XC2200 Derivatives

Errata Sheet

V1.11 2014-10

Figure 1 Critical application reset sequence

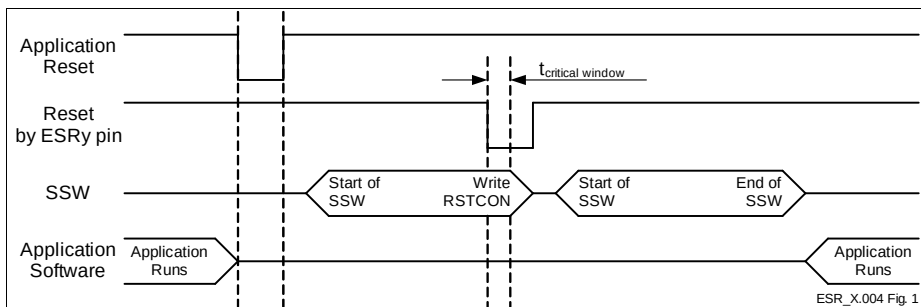
ESR X.004 Wrong Value of SCU_RSTCONx Registers after ESRy Application Reset

SCU_RSTCONx registers are reset only by Power-On, but they may be wrongly affected after a second application reset requested by an ESRy pin. This may lead to the SCU_RSTCONx register values being set to zero, which could unexpectedly disable reset sources within the user application. The conditions which lead to this behavior are:

1. First, an application reset by SW (software), CPU (Central Processing Unit), MP (Memory), WDT (Watchdog Timer) or ESRy (External Service Request y) occurs.
2. Following this, an application reset on an ESRy pin occurs.
3. If the above mentioned ESRy reset occurs during a critical time window of the SSW (startup software), then it's possible that the application will operate with the wrong SCU_RSTCONx register value. The critical time window occurs when the SSW is writing the SCU_RSTCONx registers, and at the same time, the ESRy reset request is processed by the reset circuitry. The width of this critical window $f_{critical\ window}$ is less than 13 cycles.

- Initialize SCU_RSTCONx registers by user software after any reset, or
- assure that a second application reset request with an ESR pin does not occur during the critical time window.

Figure 2 Example for Case 2: Interrupt Service for Task C delayed

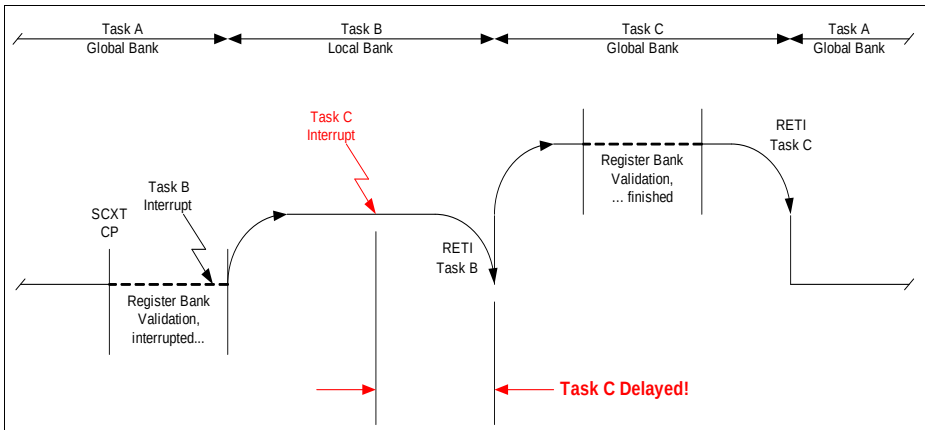
Case 2 (see also Figure 1):

- The Context Pointer CP is written to (e.g. by POP, MOV, SCXT ... instructions) within a routine (Task A) that uses a **global** register bank (bit field PSW.BANK = 00_B), i.e. the context for this routine will be modified,
- This context switch procedure (19 cycles) is interrupted by an interrupt request (Task B) which is programmed (with GPRSELx = 1X_B) to automatically use one of the **local** banks via the bank selection registers BNKSEL0...3 (i.e. the interrupting routine has a priority level ≥ 12),
- Before the corresponding interrupt service routine is finished, another interrupt request (Task C) occurs which is programmed (with GPRSELx = 00_B) to automatically use the **global** bank via the bank selection registers BNKSEL0...3 (i.e. the interrupting routine has a priority level ≥ 13).

In this case service of this interrupt request (for Task C) is delayed until bit field PSW.BANK becomes 00_B after executing the RETI instruction at the end of the routine (Task B) using the local bank.

Workaround for Case 2

When using both local and global register banks via the bank selection registers BNKSEL0...3 for interrupts on levels ≥ 12 , ensure that there is no interrupt using a global register bank that has a higher priority than an interrupt using a local register bank.

Figure 7 External Clock Drive XTAL1

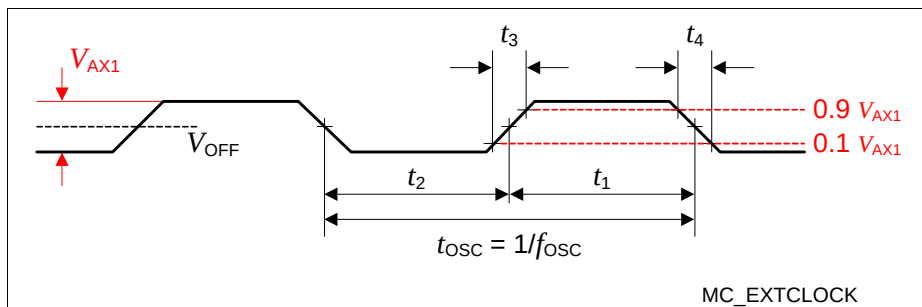
In the Data Sheet section "External Clock Input Parameters" the following table and figure should be updated (major changes are marked **red**).

1) The amplitude voltage V_{AX1} refers to the offset voltage V_{OFF} . This offset voltage must be stable during the operation and the resulting voltage peaks must remain within the limits defined by V_{IX1} .
